**Planning, Land Use and Mobility Committee
Case Report /Motion Reconsideration 11.18.20
DIR-2019-4531-DRB-SPP-MSP / Single Family Residence
4314 Canoga Drive
Woodland Hills, CA 91364**

Project Description: New Single Family Residence
Applicant / Rep: Ashraf Hemmati c. 310.709.3854; e:ashrafmemar@gmail.com
LA City Planner: Valentina Knox-Jones: 818.374.5038; valentina.knox.jones@lacity.org
Case Leader: Lauren Coffman / PLUM Chair / l.coffman@whcouncil.org
PLUM Meeting: October 3, 2019 / First Presentation
July 16, 2020 / Second Presentation
August 6, 2020 / Third Presentation
November 19, 2020 / PLUM reconsideration of Motion

Site Plan

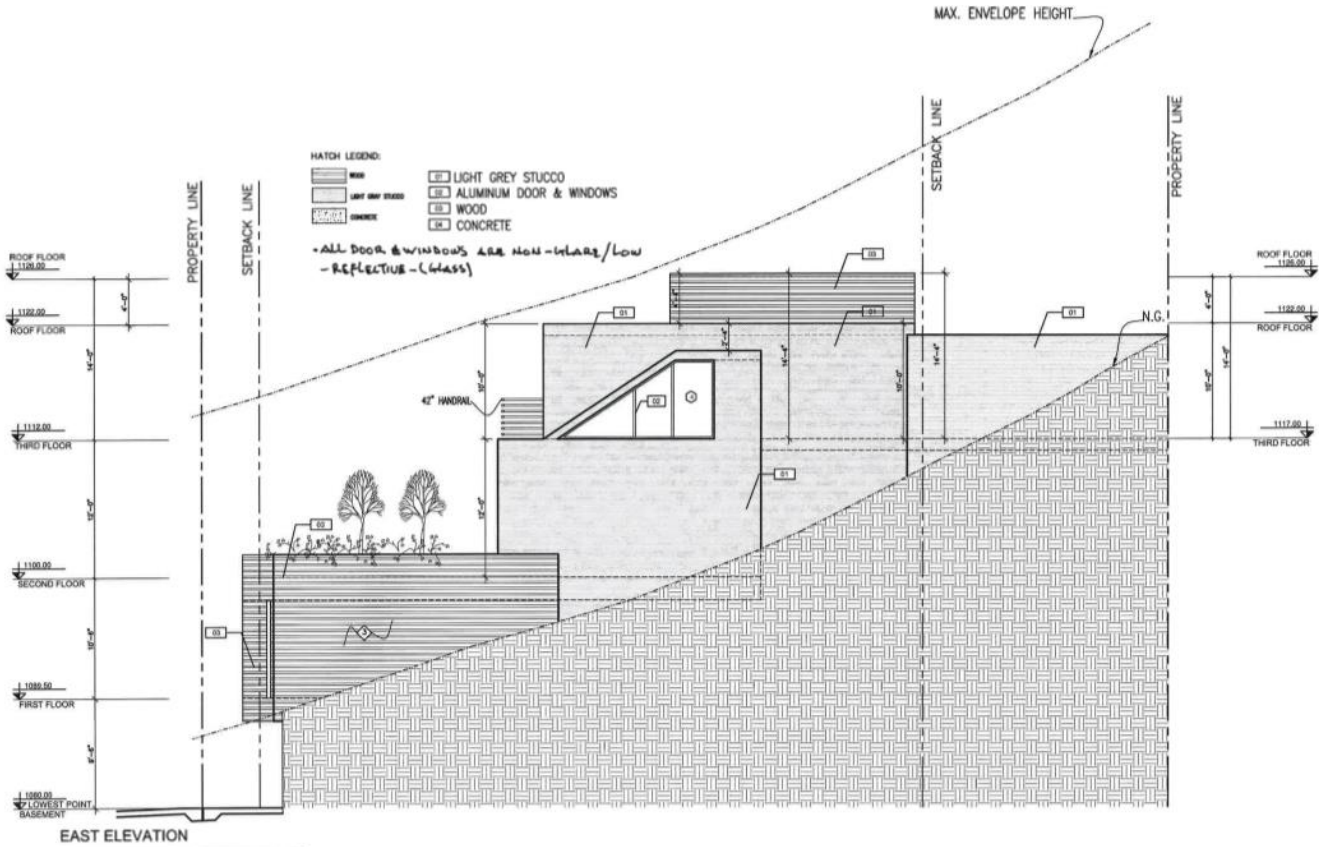
Site Drainage: Site drainage, is an issue for this site and the street, **Aside from the required planters, what is site drainage?**

1. Provide more information re: site drainage **8.6.20: Planters enlarged**
2. Locate hvac equipment on a site plan. Equipment will not be allowed on the flat roof(s) **8.6.20:Not shown**

Original Site Section

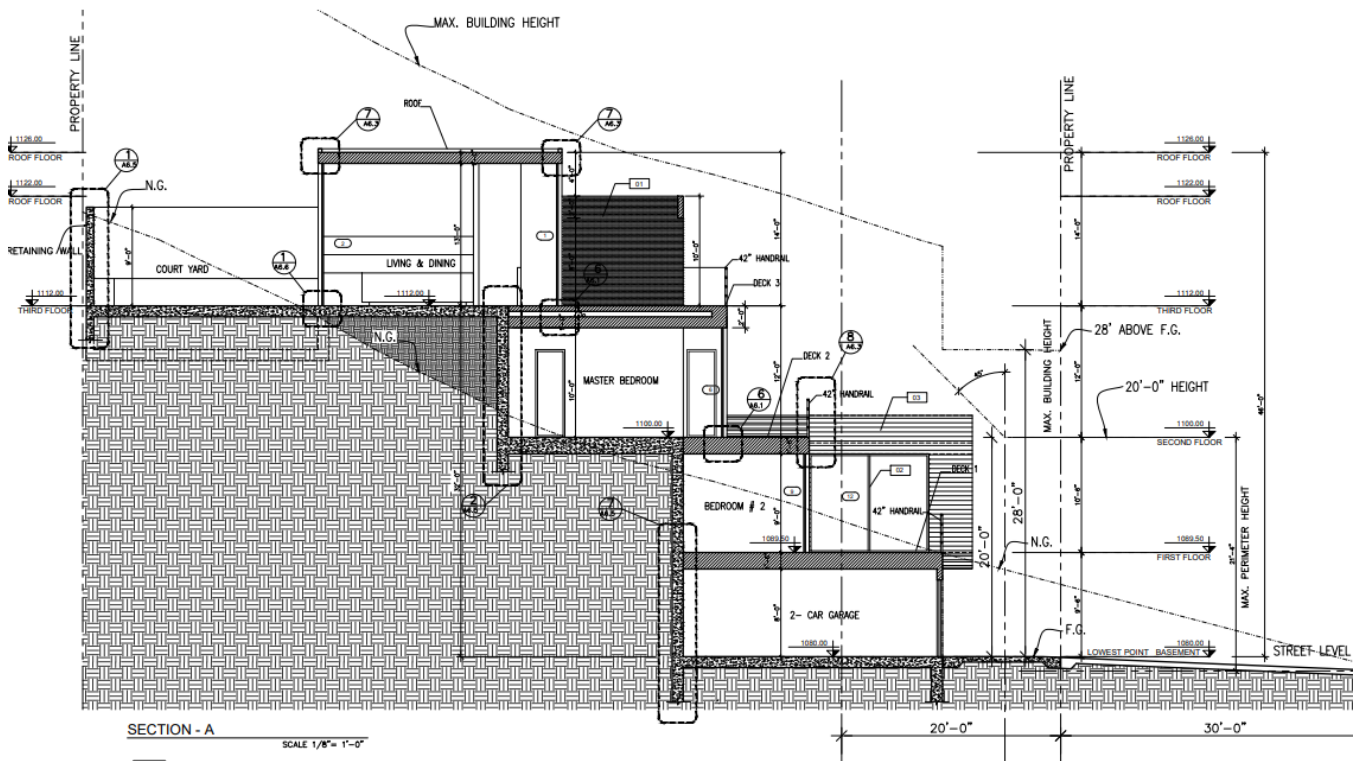
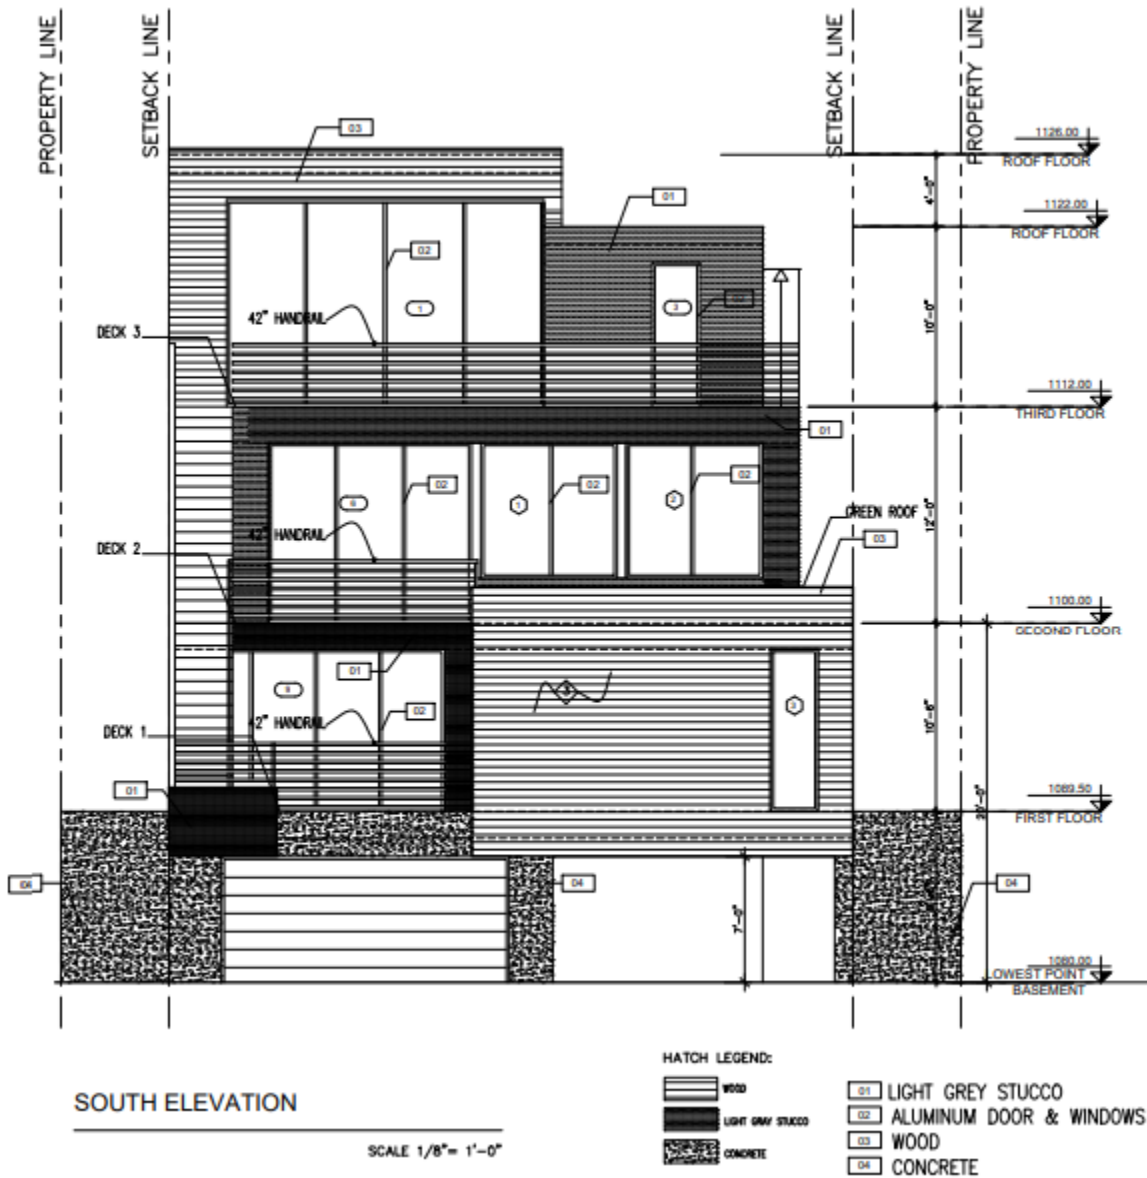
1. As per the Baseline Hillside Ordinance, the maximum envelope height for the R1-1 Zone, for a project with a roof slope less than 25% is 28 feet. This vertical height or “plumb line” height is originated at the lowest grade within 5 horizontal feet of the exterior walls of the building structure, and is the vertical distance from the grade of the site, to a projected plane at the roof structure or parapet wall located directly above and parallel to the grade.

8.6.20 The projected plane needs to be 28’ from finished or natural grade, whichever is lowest. In the New Site Section, the projected plane includes a vertical cut line. This is not part of the projected plan, as it is a vertical cut in the projected plan, where the site is being cut back as needed to conform with the 30’ wide required street upgrade. As per the definition of grade in the baseline hillside ordinance, *For the purpose of measuring height on an R1, Rs, Re or RA zoned lot in the Hillside Area, pursuant to section 12.21.C.10 of this code, Hillside Area Grade shall be defined as the Elevation of the finished or natural surface of the **ground**, whichever is lower, or the finished surface of the **ground** established in conformance with a grading plan approved pursuant to a recorded tract or parcel map section.* The vertical cut of the ground should not be considered the grade. Therefore, the projected plan should be set at 28’ above the finished grade, which is the driveway.

- As per the Baseline Hillside Ordinance, on a substandard hillside street, no portion of a building or structure within 20 feet of the front yard lot line shall exceed 24 feet in height. The 24 foot height shall be measured from the midpoint of the street on which it faces.

8.6.20: As per the New Site section, which shows the street, the building seems to comply.

Original West Elevation

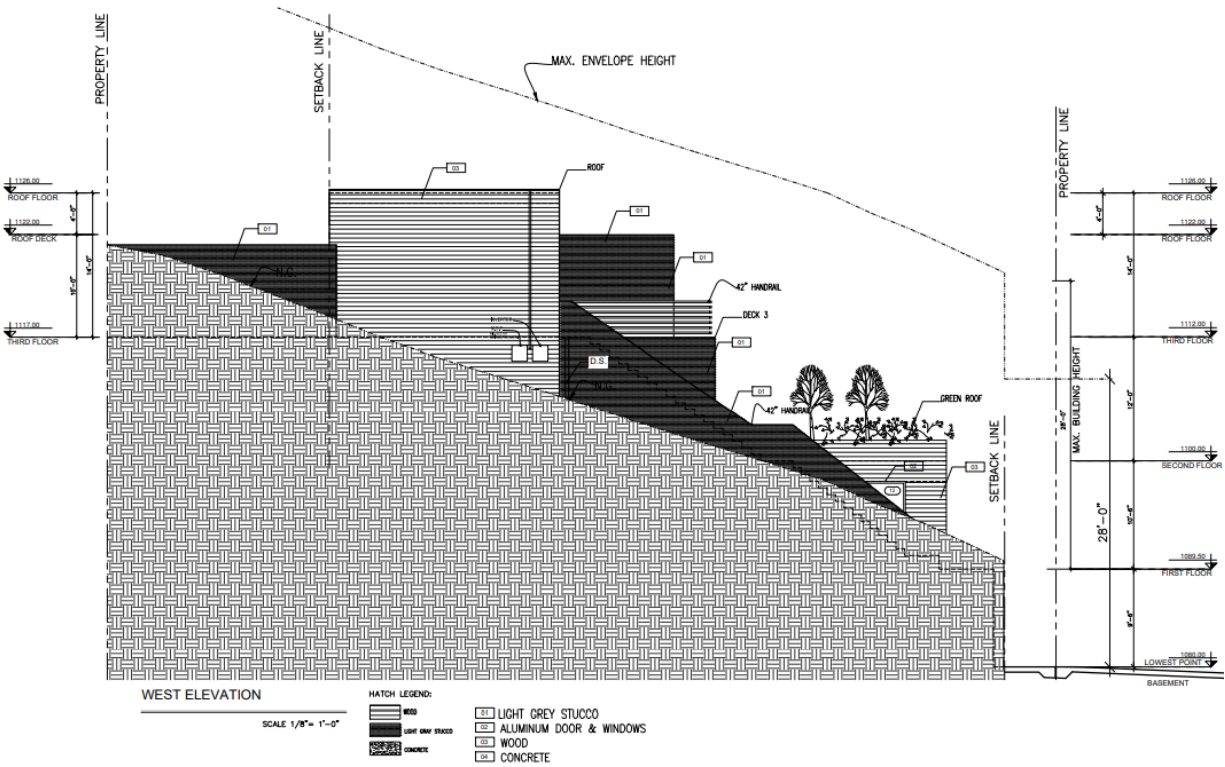
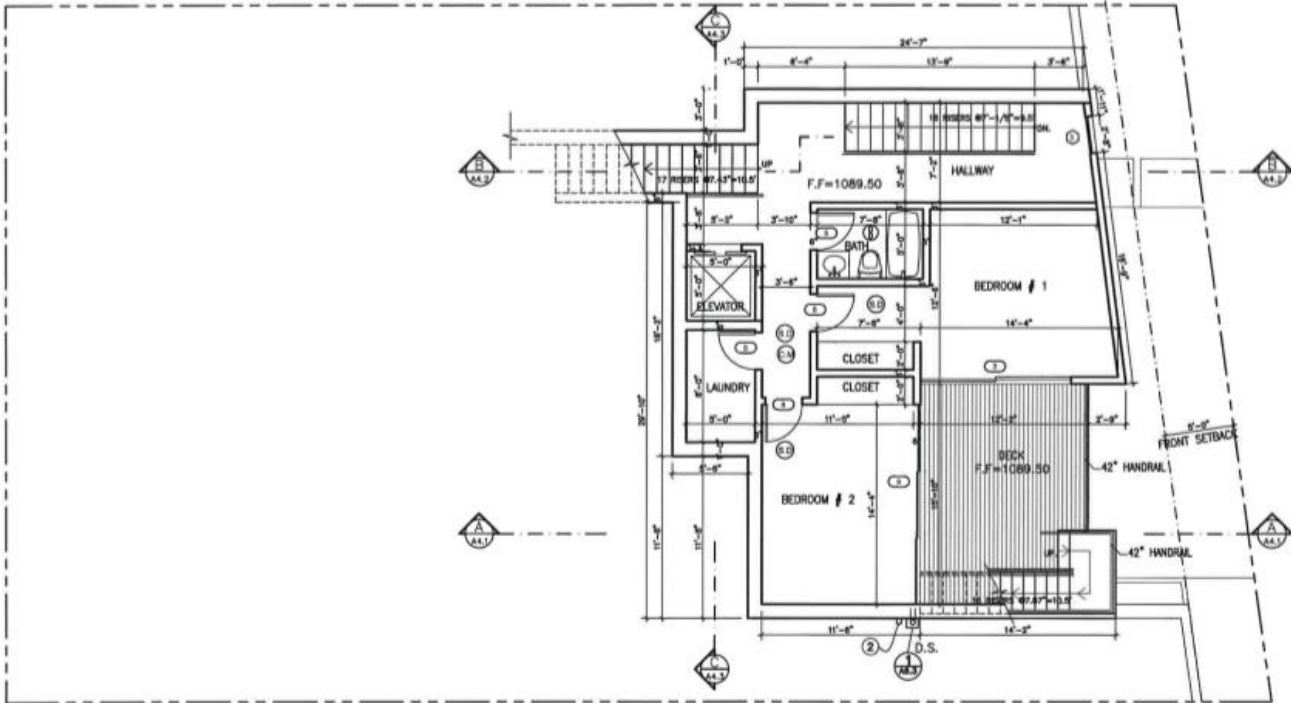
2. The Overall Height is indicated as 50’ from finished grade to the top of the flat roof / parapet. This building appears to be taller than the allowed height of 45 feet by the *Baseline Hillside Ordinance*.

8.6.20: The Baseline Hillside Ordinance states, as per the Zoning Administrator’s Authority (12.21 C.10.(d)2 of the LAMC) *The Zoning Administrator may allow structures which exceed the maximum envelope height requirement of table 5 – Maximum Height of Structures; However, the increase in height may not result in a*
